# Access Compliance Report

## Public Rights-of-Way

### (Curb Ramps)

Intersection ID: 17498	Main Street: BAINBRIDGE_RD	Cross Street: KNICKERBOCKER_DR	Location: W
ADA ID: 4FC980A852A9	Ramp Type: Directional1	Initial Pass/Fail: Fail	Overall Compliance: No
Severity Score: 1.25			
Codes/Mitigation Info/Possible Solution		Field Measurements/Component Compliance

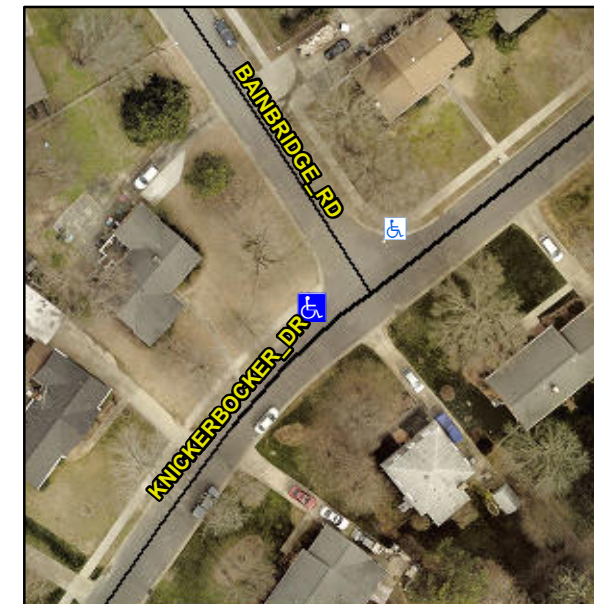
**R304.5.3**

Compliance	Description	Data	Compliance	Description	Data
N/A	Ramp Length (in)	106.0	N/A	Grade Break?	N/A
Yes	Ramp Width (in)	60.0	N/A	Grade Break Slope (%)	0.0
Yes	Ramp Slope (%)	3.7	N/A	Grade Break XSlope (%)	0.0
No	Ramp XSlope (%)	2.9			
N/A	Flare Type LT	N/A	N/A	Flare Type RT	N/A
N/A	Flare Slope LT (%)	N/A	N/A	Flare Slope RT (%)	0.0
N/A	Flare Traversable LT?	N/A	N/A	Flare Traversable RT?	N/A
N/A	Landing Length (in)	0.0	N/A	DWS Provided?	N/A
N/A	Landing Width (in)	0.0	N/A	DWS Contrast?	N/A
N/A	Landing Slope (%)	0.0	N/A	DWS Length (in)	N/A
N/A	Landing X Slope (%)	0.0	N/A	DWS Full Width?	N/A
N/A	Landing Curb? (Y/N)	N/A	N/A	DWS Offset LT (in)	N/A
N/A	Shared Landing?	N/A	N/A	DWS Offset RT (in)	N/A
N/A	Gutter Ponding?	0.0	N/A	Gutter Slope (%)	N/A
N/A	Gutter Lip Ht (in)	0.0	N/A	Gutter X Slope (%)	N/A
N/A	Painted X Walk1?	No		Road Slope (%)	6.5
	X Walk 1 Direction	To NE		Road X Slope (%)	3.5
	X Walk 1 Width (in)	N/A		Clear Space?	N/A

**Remove & Replace Entire Ramp.**
